RGDSS Memorandum

Subject: RGDSS Peer Review: Review of wells and areas of high model residuals

Date: June 22, 2015

Figure 13: La Garita Creek alluvial fan area.

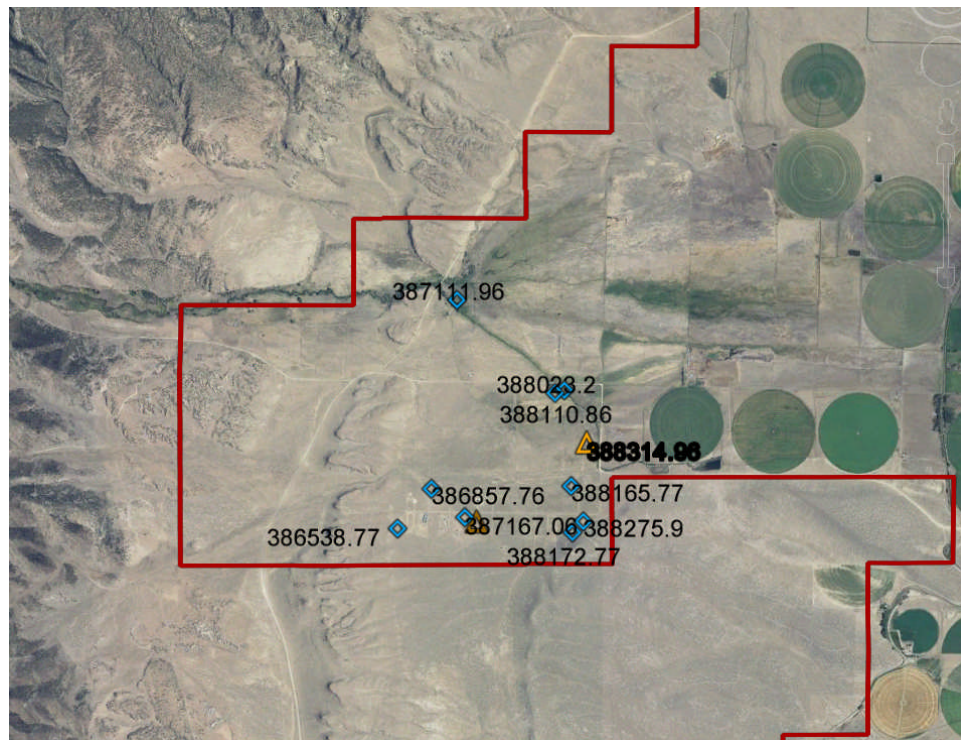
There are 11 wells in this area (see Figure 13), of which HRS reviewed records from all 11. Of these 11, only 2 are recommended for retention in the calibration set, and those two are recommended to be reassigned to L3 instead of L2, their current layer assignment. The other 8 are recommended for omission, because the well records show that they are completed in bedrock formations: either the Fish Canyon Tuff or the Carpenter Ridge Tuff. These formations are not reflective of the SLV aquifer layering intended to be represented at these locations.

Recommended calibration weighting changes: Of the 10 high residual wells in this group, only 2 are recommended for retention in the calibration set, and those two are recommended to be reassigned to L3 instead of L2, as discussed previously.

Recommended future modeling and sustainability metrics enhancements: With the exception of the two wells recommended for retention (with layer reassignment) the other wells in this area, in our opinion, would not be suitable for inclusion in future sustainability metrics and should be omitted.

Figure 14: Upper Alamosa /La Jara Creek alluvial fan area.

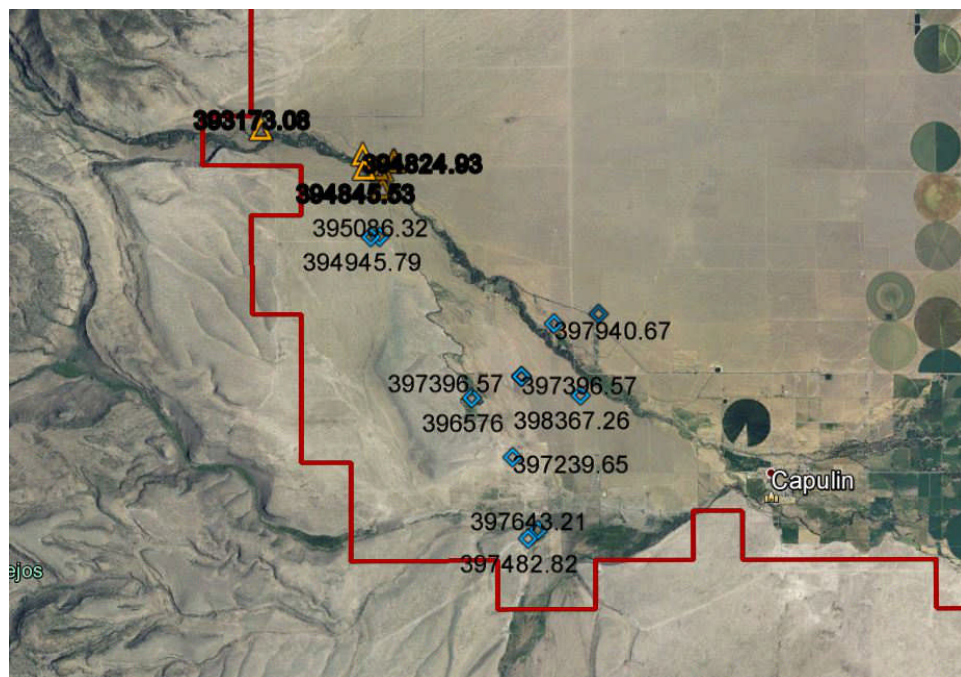
Of the 8 wells in the L1 subset (all of which have negative residuals), we recommend deferral of 6 wells at this time due to a high likelihood of perched water table in this area, and layer reassignment to the remaining two. Well records in this area show a shallow water table a few tens of feet deep, probably associated with the Alamosa River and its shallow alluvium, and a deeper water level, generally at least 100 feet deep, with an intervening unsaturated zone.

Of the deeper subset of 11 wells, 5 are recommended for omission from the calibration set for several reasons, chief of which is our inability, based on the available well records, to determine with confidence which aquifer layer a well represents. Three wells of this subset are recommended for layer reassignment, and we recommend that the remaining 3 wells be retained in their current layer assignments.

Recommended calibration weighting changes: Several wells in this group are recommended for omission or layer reassignment. None are recommended for calibration weighting changes.

Recommended future investigations: Verify presence of unsaturated zone below near-surface alluvium in upper Alamosa River area.

Recommended future modeling and sustainability metrics enhancements: For future phases of modeling, we recommend assigning a lower vertical conductance between L1 and L2, to allow shallow water table to remain perched, thus representing the observed condition. Perched wells are not likely to be suitable candidates for future sustainability enhancements. Other wells in this group most likely would be suitable for inclusion in future sustainability metrics, as they probably represent SLV regional head changes in the aquifer layers represented in the RGDSS model.

Figure 15: Upper Conejos River and San Antonio River areas.

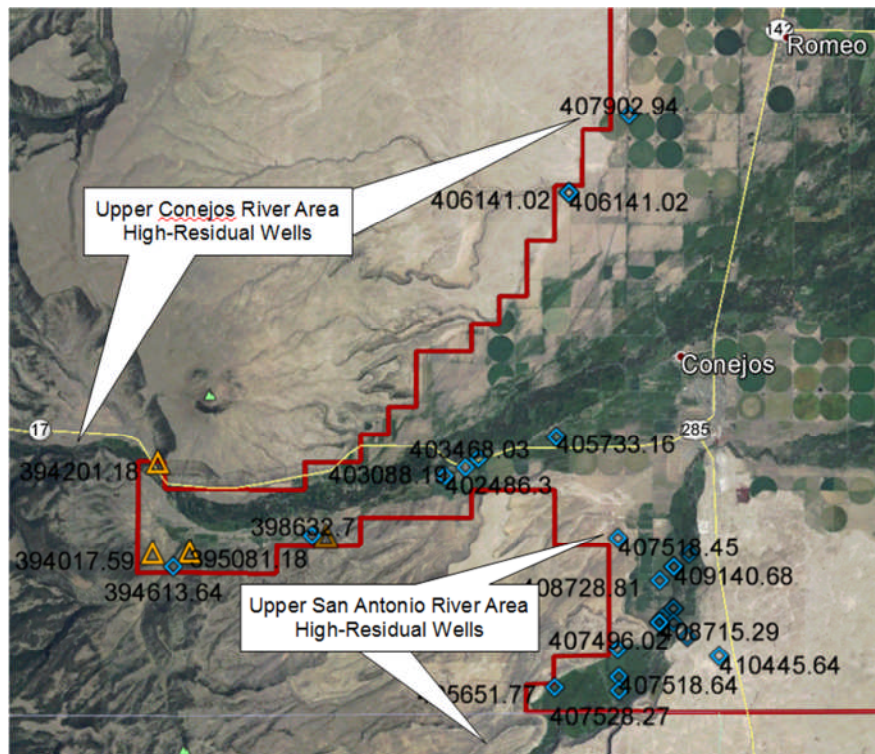
There are 14 wells in this area (see Figure 15), of which HRS reviewed records from all 14. Wells in this group are of two types: wells located in the Conejos River valley, and wells located on bluff and upland slopes above the valley. The majority of the wells located in the Conejos River valley (8 wells), in our opinion, reflect the water table at their respective locations, and are appropriately assigned by layer. We have made specific layer recommendations on a well by well basis for a few wells. The majority of the wells in this set in the Conejos River valley show positive residuals between 100 and approximately 240 feet. In our opinion this consistency in positive residuals indicates a need to revisit the hydrostratigraphy of this area to see whether there is more subtle layering than appears in driller's reports, or other hydrogeologic factors, that may be causing the consistently high residuals.

There are 6 wells of the 14 in this area that are located on bluffs or upland slopes above the river valley. With one exception, these wells show negative residuals of between 100 and 220 feet. One well is recommended for omission because it is duplicative of another well in the set. For the others, we have recommended well-specific layer reassignments.

There are 17 wells in this area (see Figure 15), of which HRS reviewed records for all wells. There are three sets of two wells each that have the same UTM coordinates but separate / different permit numbers. This is due to how the UTMs were selected: based on footages from section lines or by quarter quarter. All of the wells in this group are currently assigned in layers 2, 3, or 4; none are in L1. With one exception (well permit no. 22783-A, with a positive residual of 312 feet) the wells reviewed show negative residuals between approximately 120 and 215 feet. Seventeen wells in this group have been recommended for omission from the calibration set, as they appear to be dual completed in L1 and L2 or L2 and L3, thus the water level does not represent a single aquifer layer. Seven wells are recommended for reassignment from L3 to L1 and one from L2 to L4.

Recommended calibration weighting changes: Several wells in this group are recommended for omission or layer reassignment. None are recommended for calibration weighting changes.

Recommended future investigations: As discussed previously, in our opinion there is a need to revisit the hydrostratigraphy of this area to see whether there is more subtle layering than appears in driller's reports, or other hydrogeologic factors, that may be causing the consistently high residuals in the wells located in the Conejos River valley.

Recommended future modeling and sustainability metrics enhancements: We recommend deferring wells in this group from inclusion in sustainability metrics for the present, until the hydrostratigraphy can be revisited and the model layering revised in this area, if needed.

Recommended calibration weighting changes: Seven wells are recommended for omission from the calibration set due to dual completion in L1 and L2 or L2 and L3. Eight wells in this group are recommended layer reassignment with two wells in this group remaining the same. None are recommended for calibration weighting changes.

Figure 16: High residual wells in the Costilla Plain area.

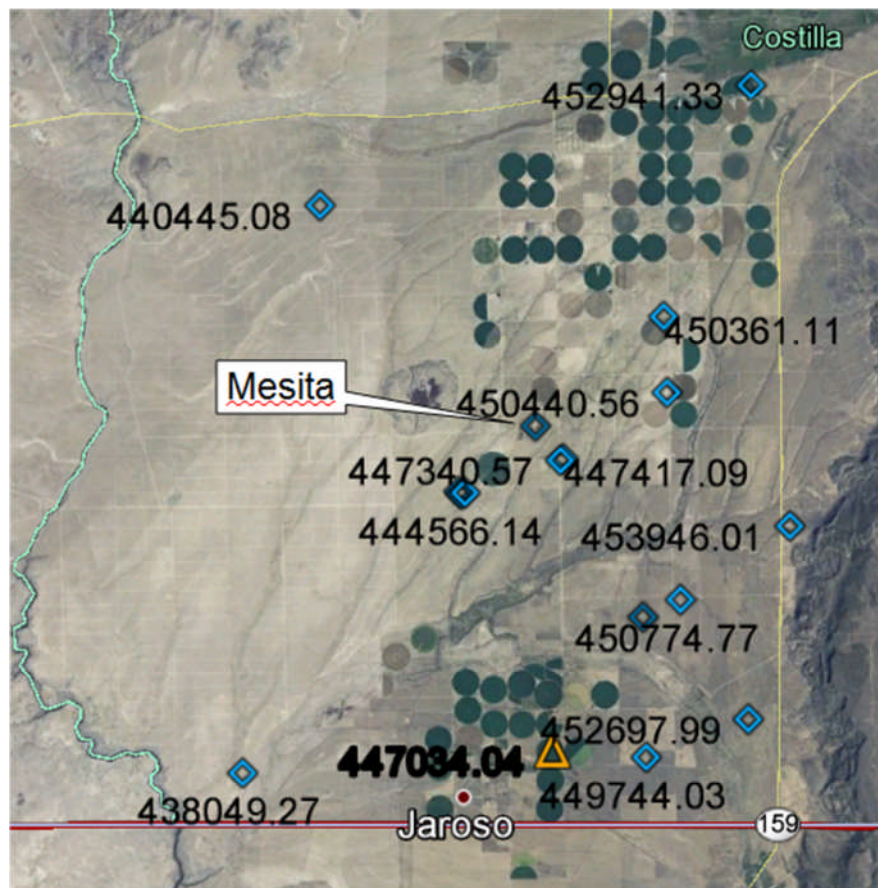
Five of the high residual wells are located generally north (and either NW or NE) of Mesita. Two of these are recommended to be omitted from the calibration set: Permit no. 5825-R is

suspected to have influence from L2, in addition to L3 and L4 in which the well is screened. The multiple layers leads to the measured water level not being identifiable as representative of one aquifer layer, and should be omitted. Well permit no. 56692-F is recommended to be omitted unless further work shows that this well is not located in an isolated fault block of Servilleta formation, as we suspect from its location and the aeromagnetic geophysical survey coverage in the area. The other three wells in this subgroup all appear to appropriately assigned.

The remaining 12 of the 17 high residual wells in the Costilla Plain are generally located south (and either SE or SW) of Mesita. Of these 12, two are recommended for omission because no log could be found to enable us to verify the hydrogeology. Three wells are appropriately assigned to L3. The remaining wells are recommended for layer reassignment; most from L2 (current assignment) to L3. These wells all appear from the records to reflect water levels in the Servilleta formation aquifer, which represents L3 in the RGDSS model in this area.

Recommended calibration weighting changes: Several wells are recommended for omission from the calibration set due to lack of logs. Several wells in this group are recommended for layer reassignment. None are recommended for calibration weighting changes.

Recommended future modeling and sustainability metrics enhancements: The wells in this group for which the aquifer layer has been checked and verified most likely would be suitable for inclusion in future sustainability metrics.

Figure 17: High residual wells in the Culebra Graben and Rito Seco areas.

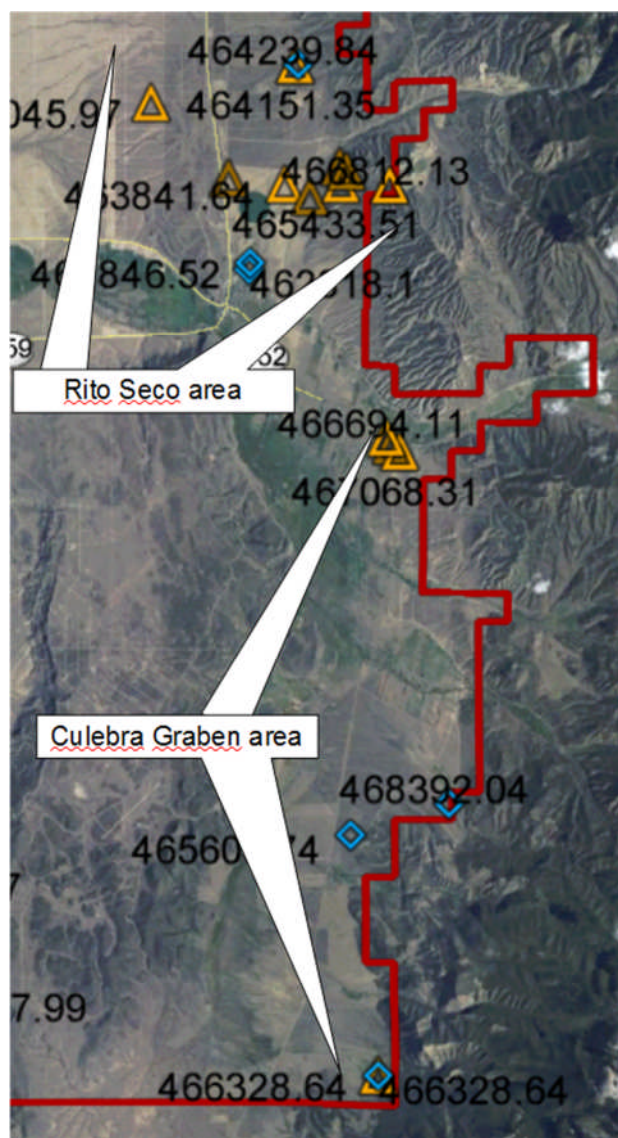
Of the seven wells located in the Culebra Graben area south of San Luis, two are recommended for omission from the calibration set. Permit no. 246273 has a poor driller's log so that the layer represented by the water level cannot be verified, and also is located closely adjacent to the mapped location of one branch of the Sangre de Cristo fault in this area. Permit no. 31587 has no screened interval documented, and so the aquifer layer could not be verified. HRS was able to verify appropriate layer assignment for two wells, and the remaining 3 wells are recommended for layer reassignment based on the driller's logs and well completion reports.

The remaining 12 wells in this group are all located generally NE to NW of San Luis, in the Rito Seco area. Of these 12, three are recommended for omission from the calibration set due to duplicative wells also in the high-residual well list. The majority of the remaining 10 wells are recommended for reassignment from L1 (current assignment) to L2 or L3, depending on the well depth and the stratigraphy reflected on the well logs. Most of these are not in L1 (alluvium) but instead reflect either shallow Santa Fe formation (L2) or deeper Santa Fe formation (L3).

Recommended calibration weighting changes: Several wells are recommended for omission from the calibration set due to duplicative entries in the high-residual well list. Several wells in this group are recommended for layer reassignment from L1 to either L2 or L3. None are recommended for calibration weighting changes.

Recommended future modeling and sustainability metrics enhancements: The wells in this group for which the aquifer layer has been checked and verified most likely would be suitable for inclusion in future sustainability metrics.

Figure 18: High residual wells in the Fort Garland / Sangre de Cristo Creek area.

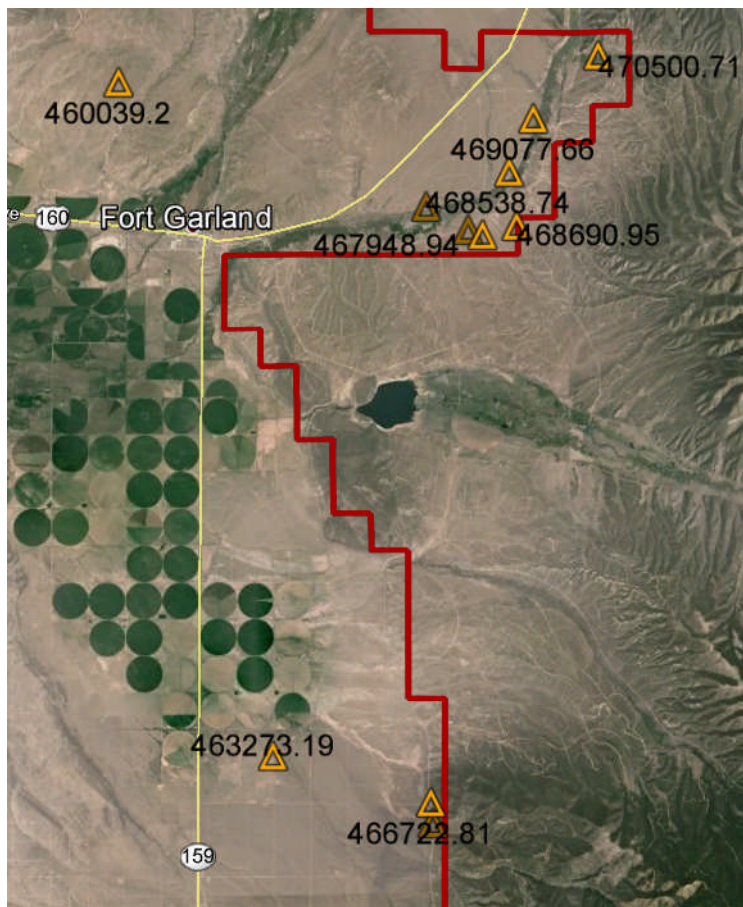
Three wells are located south of Fort Garland. Of these, two are recommended for omission from the calibration set. One (permit no. 67007-F) showed inconsistent and contradictory water levels, logs, and total depths between records. Another (51506-F) appears to be mislocated, as the written record shows that it is located in the Zapata Subdivision, which is approximately 20 miles NW of the permitted location. The third well in this subarea (permit no. 47016-FR) is recommended for layer reassignment from L1 to L3, as the log indicates the well is completed in Santa Fe formation, which is L2 and L3 in this area.

The remaining 7 wells are located generally east of Fort Garland, in or near the valley of Sangre de Cristo Creek (see Figure 18). Two of these 7 are recommended for omission from the calibration set. Well permit no. 85414 appears to be dual-completed in L1 and L2, so that the

water level is probably not reflective of one aquifer layer. The driller's report for Well permit no. 65009 is of poor quality and unreadable on the best copy available, and no screened interval is reported. Of the remaining 5 wells, all are recommended for reassignment from L1 to L2, as the logs for all 5 show that the wells are completed in the upper Santa Fe formation, which is L2 in this area.

Recommended calibration weighting changes: Several wells are recommended for omission from the calibration set for various reasons as discussed previously. Several wells in this group are recommended for layer reassignment from L1 to L2. None are recommended for calibration weighting changes.

Recommended future modeling and sustainability metrics enhancements: The wells in this group for which the aquifer layer has been checked and verified most likely would be suitable for inclusion in future sustainability metrics.
